# EIGHTEEN SUNSET

DESIGN REVIEW BOARD

FINAL SUBMITTAL JANUARY 4, 2021

DESIGN REVIEW BOARD *PROPOSED*

# TRANSVERSE SECTION

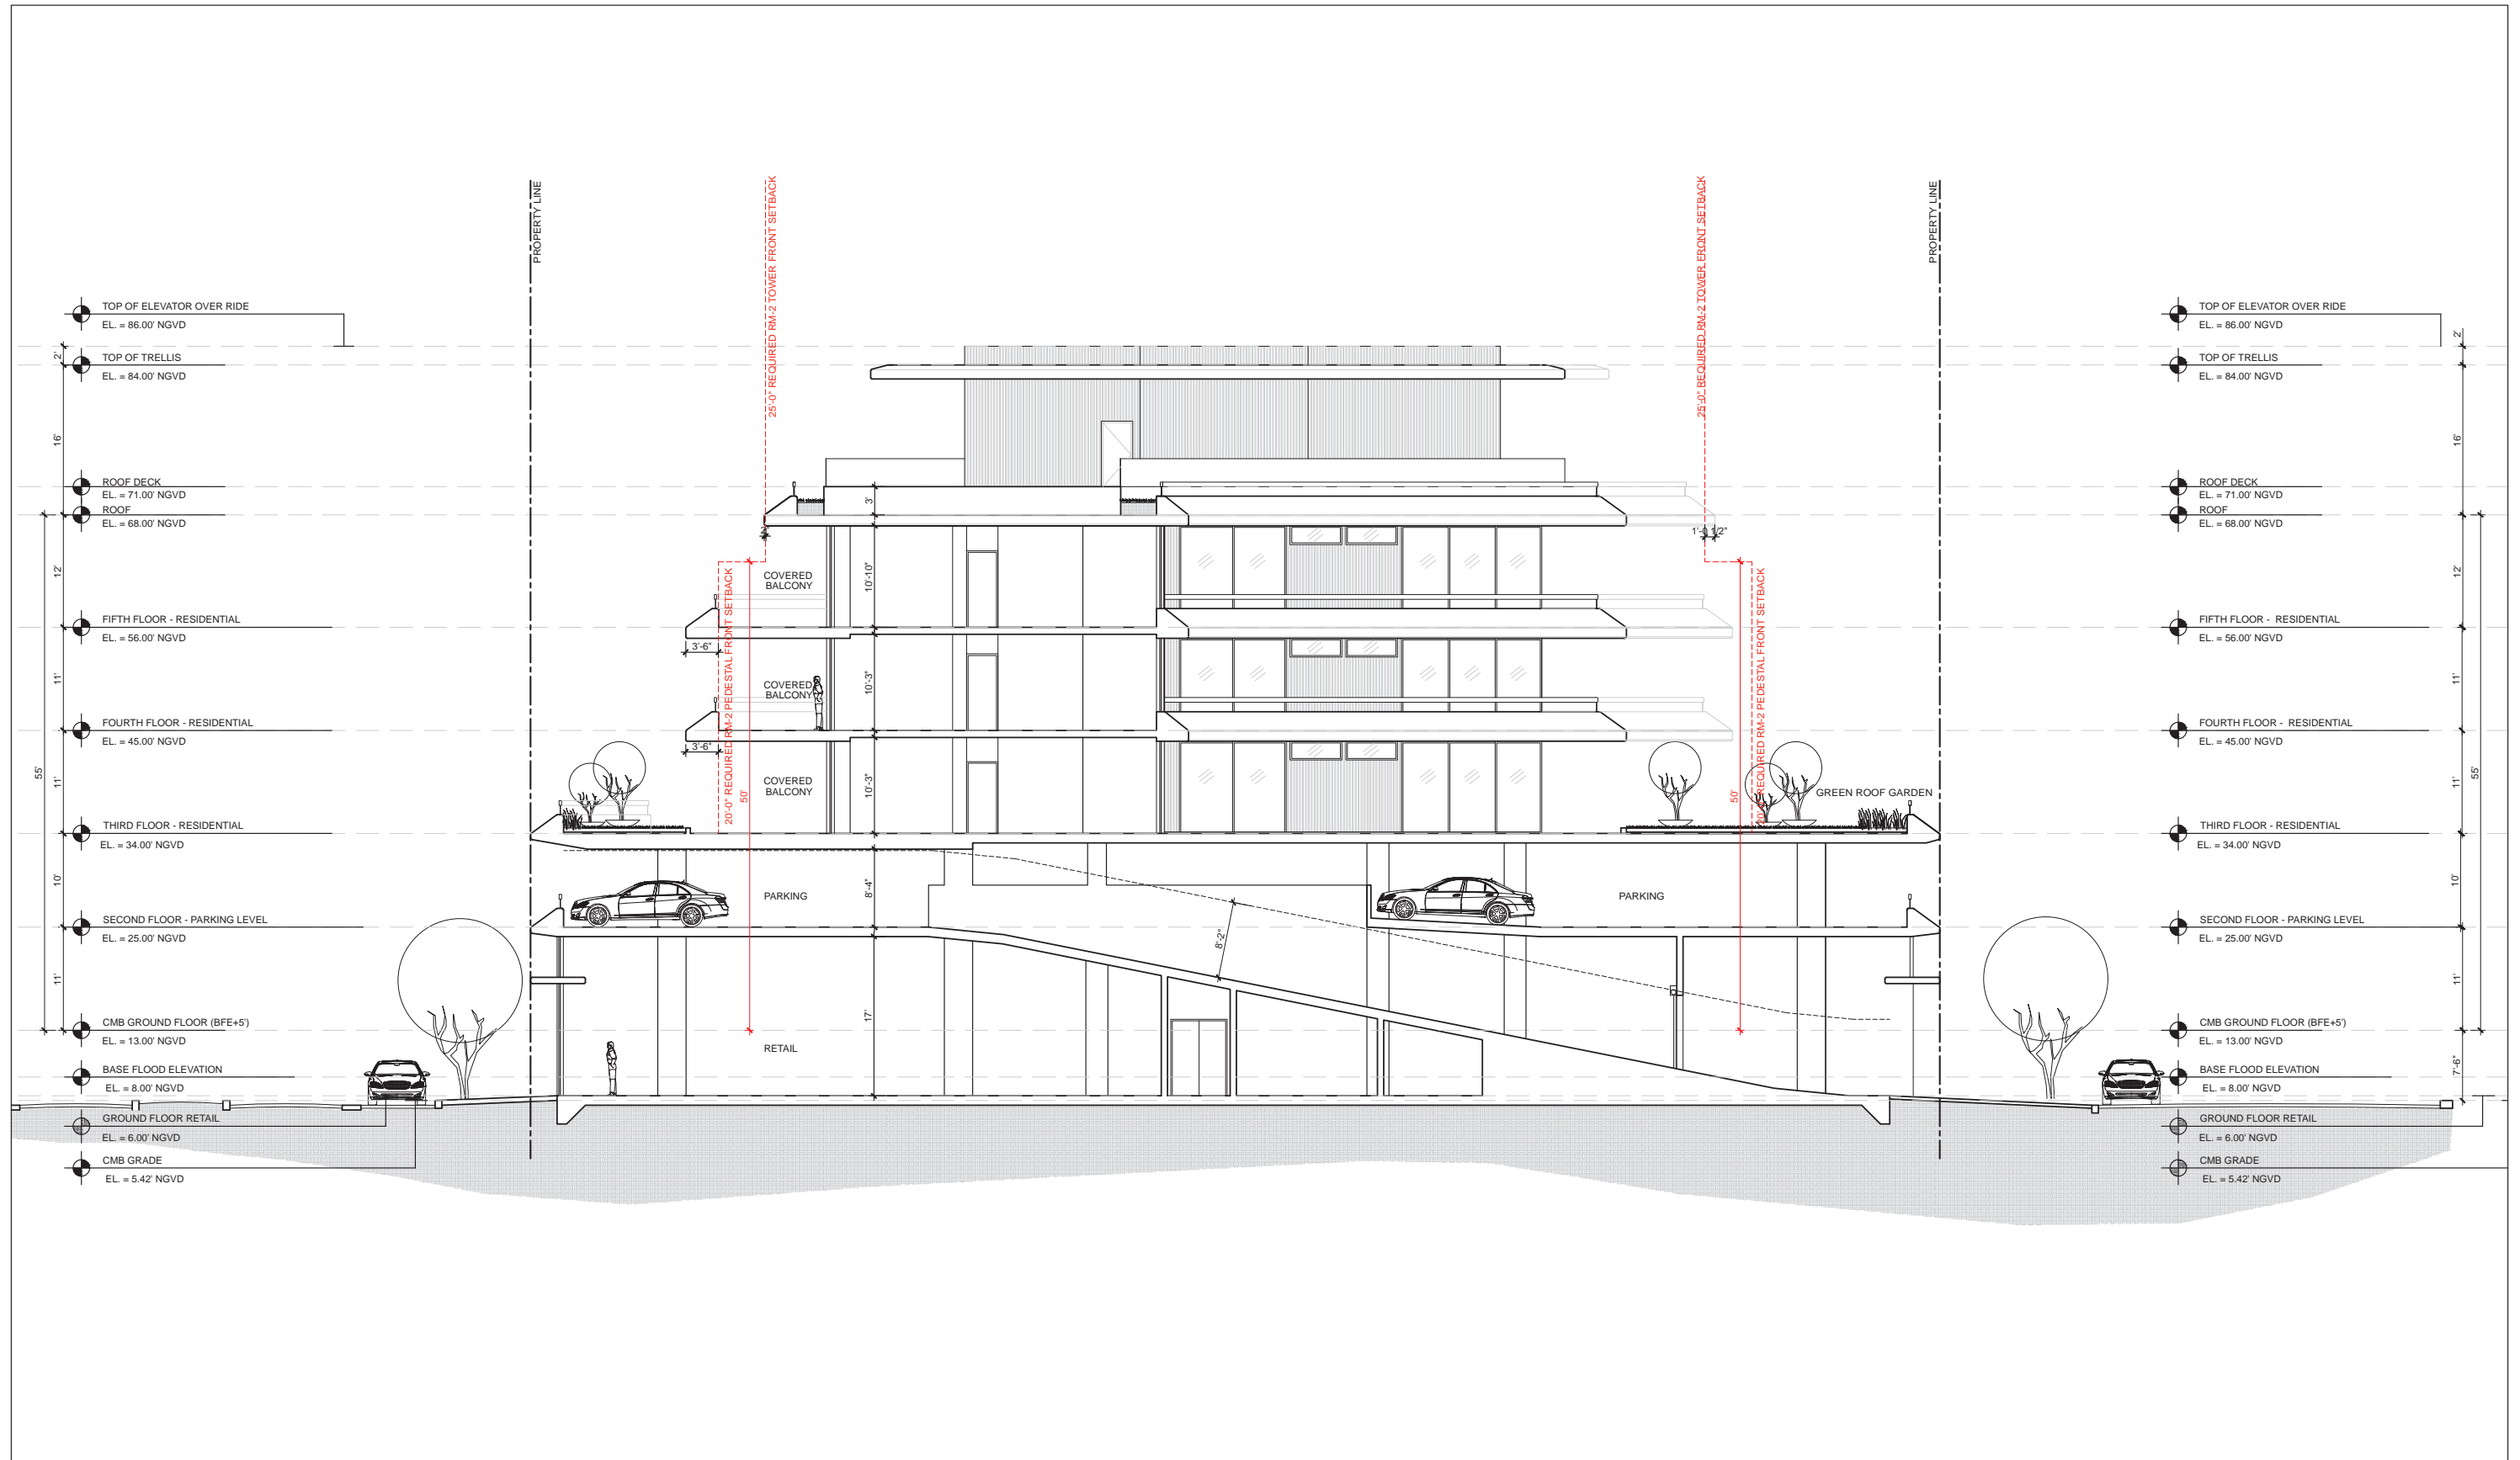
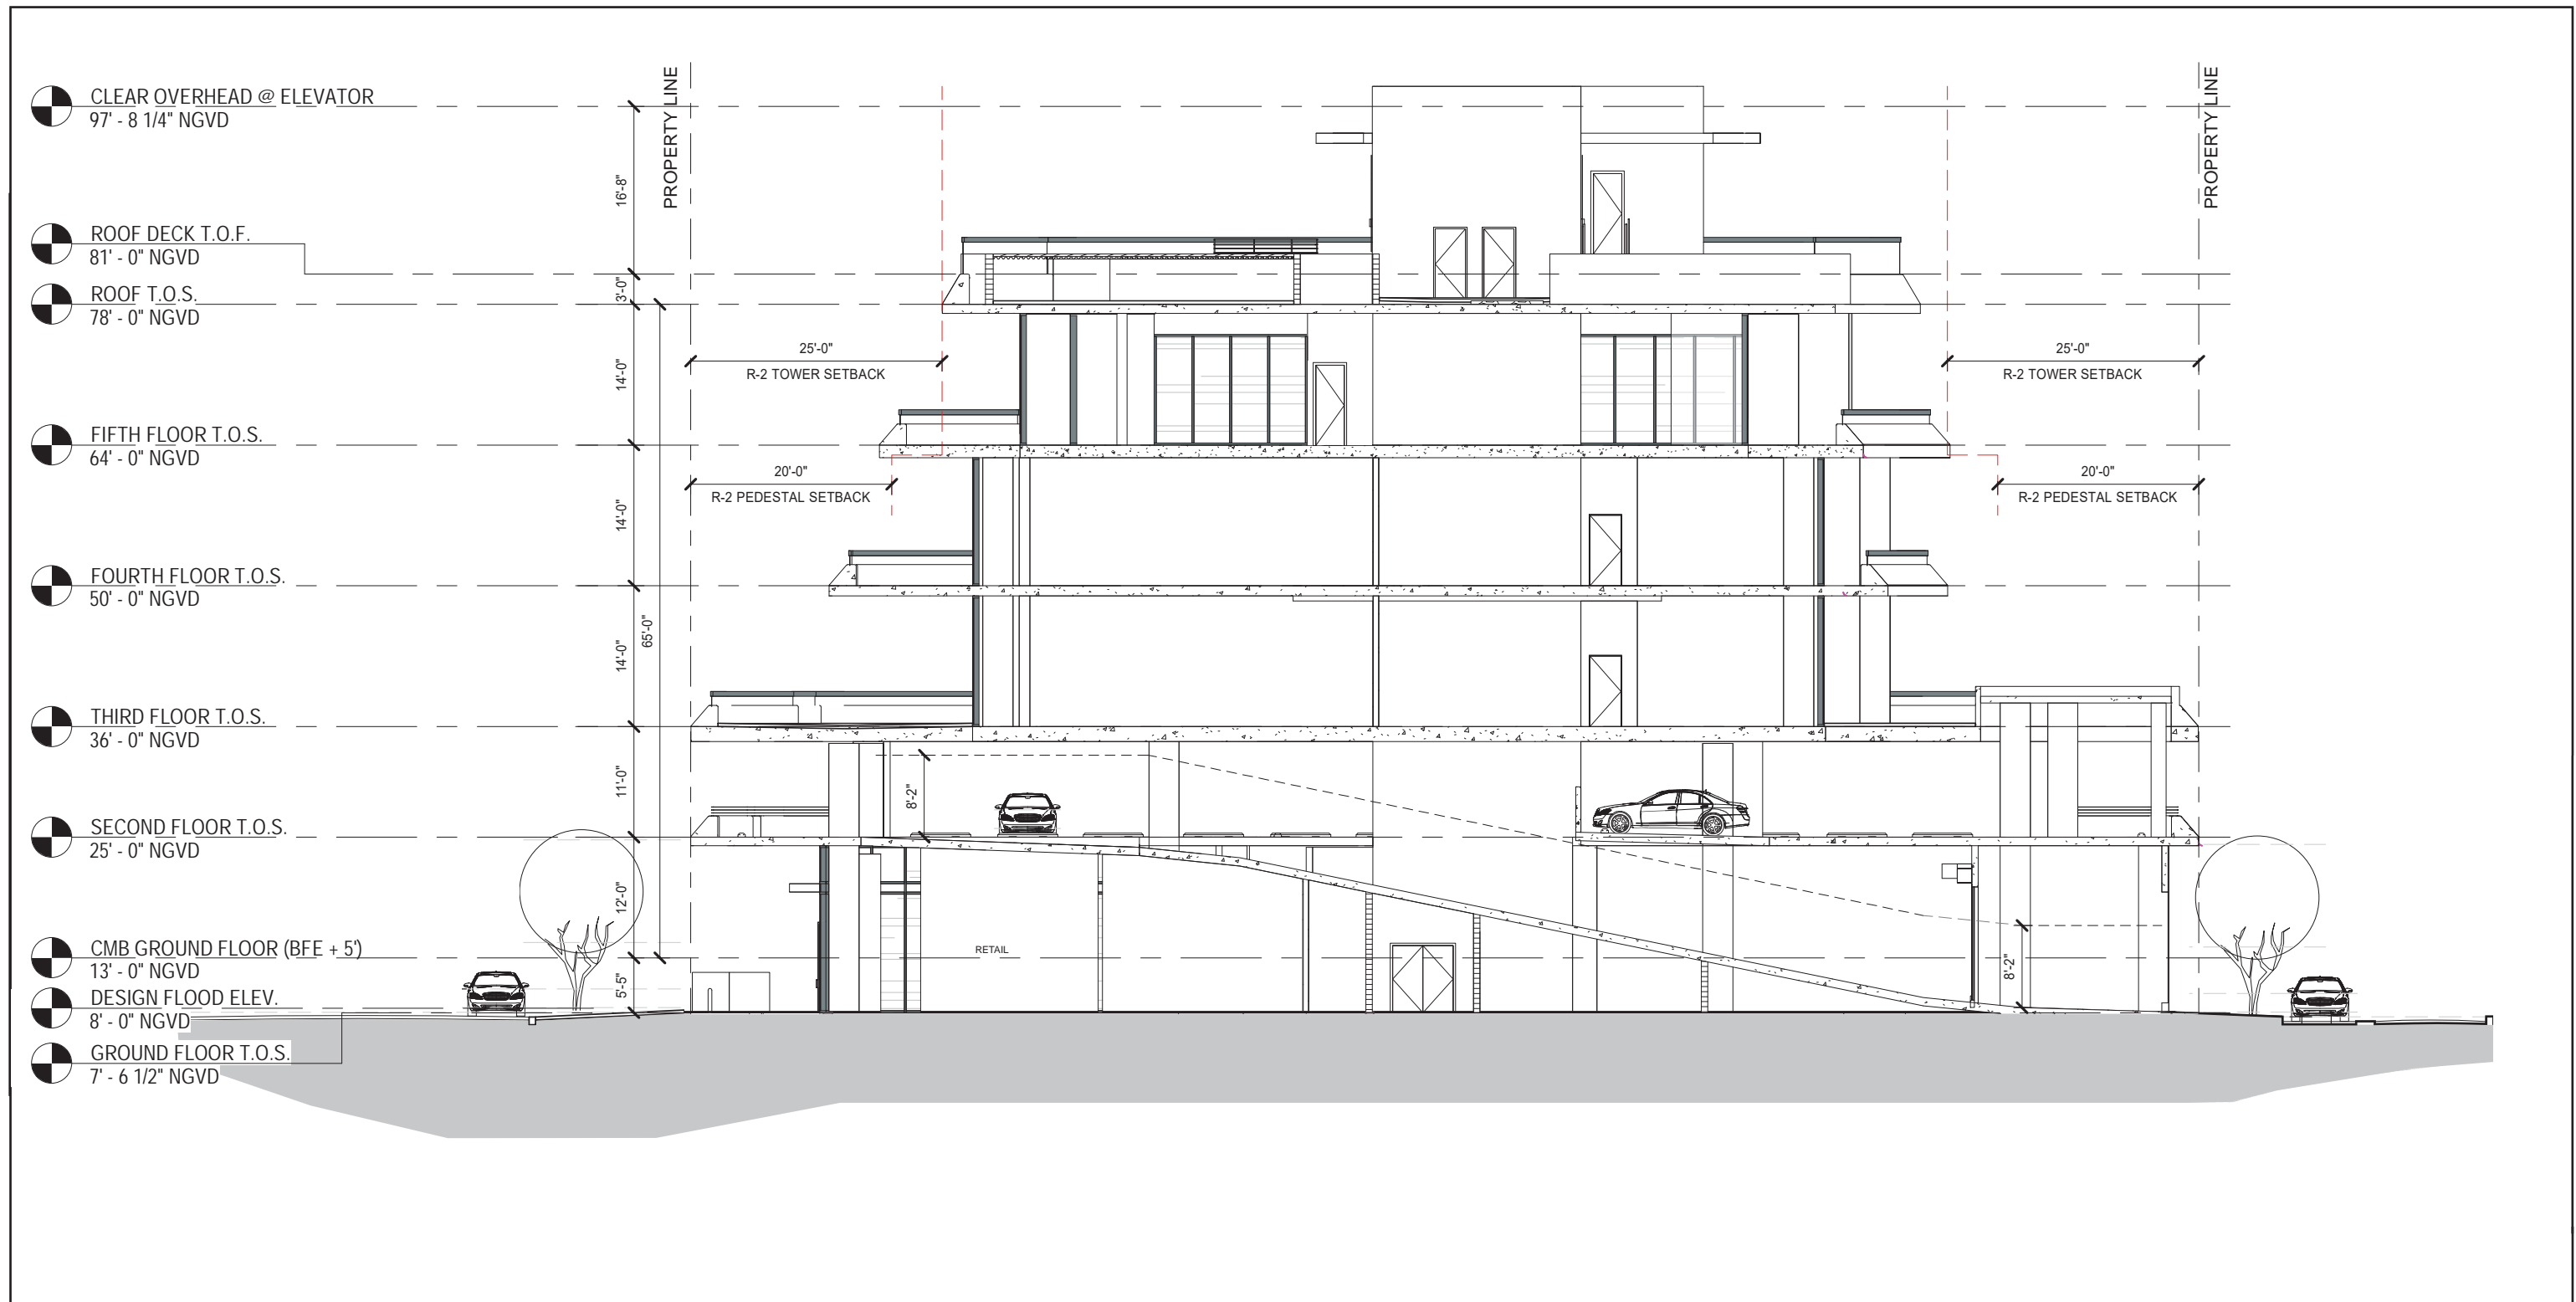
NO CHANGE IN ELEVATION HEIGHTS
